DEP File No. 0570005-019-AC; PSD-FL-339

Sulfuric Acid Production Increase, Plant City Phosphate Complex

This letter is in response to the e-mail you received from Ron Dennis, EPCHC, on May 6, 2004 regarding the draft permit for "C" and "D" Sulfuric Acid Plants. The attachment provides answers to the two questions posed in Mr. Dennis's e-mail.

Figure 1

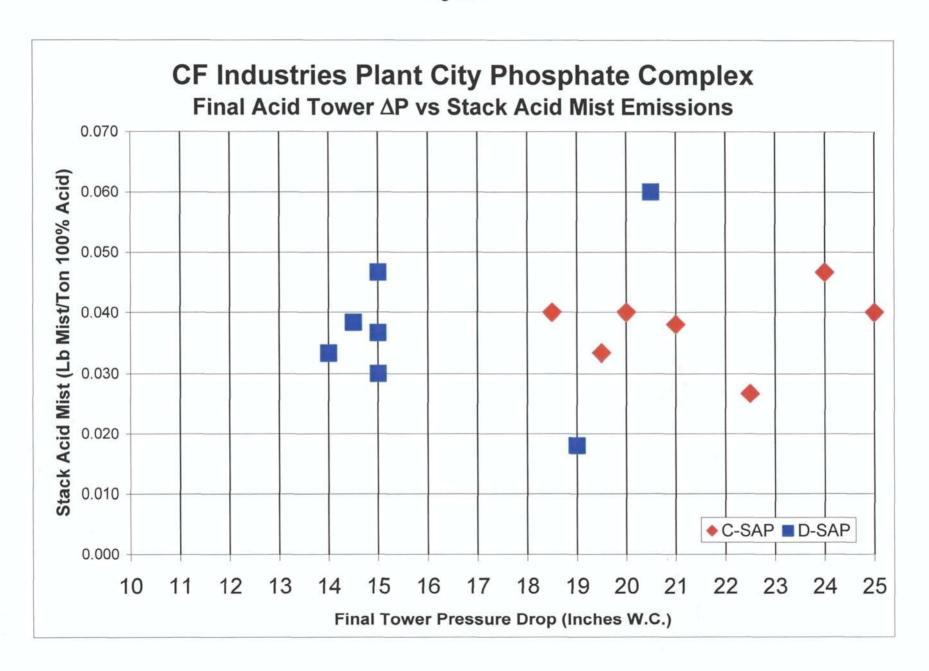
1. On Page 4 of 15, it states that "the packing in the remaining four absorption towers may be replaced with "in kind" packing as the current packing exhibits high pressure drop and requires replacement." Do we have any timeline from CF as to when this will occur? What impact does the high-pressure drop have on performance with respect to emissions to the atmosphere?

A newly repacked tower will typically exhibit an overall pressure drop in the range of 13" to 15"  $H_2O$ . Over several operating cycles the tower pressure drop will gradually increase. When the pressure drop becomes excessive, the towers are repacked as part of normal plant maintenance to maintain the plant's operating efficiency.

The remaining four towers could require repacking within the next two to eight years, depending on the performance of the existing packing as compared to the replacement packing, and the value of energy. Assuming a 10-year repacking cycle, CF would expect the following repack schedule: C-SAP Interpass Tower in 2009 and the D-SAP Drying, Interpass, and Final Towers in 2010.

The high pressure drop has no relationship to emissions as illustrated in the attached Figures 1 and 2, which show annual compliance test data for "C" and "D" Plants acid mist and SO<sub>2</sub> emissions versus the Final Tower pressure drop. Sulfuric acid mist (SAM) is removed from the gas stream by de-misters located downstream from the tower packing, and SO<sub>2</sub> is removed by chemical conversion to SO<sub>3</sub> at a location upstream of the towers. Changes in pressure drop within the normal range of operation are not sufficient to affect the emission rates.

The replacement of the packing will not increase emissions and will not increase the permitted capacity.
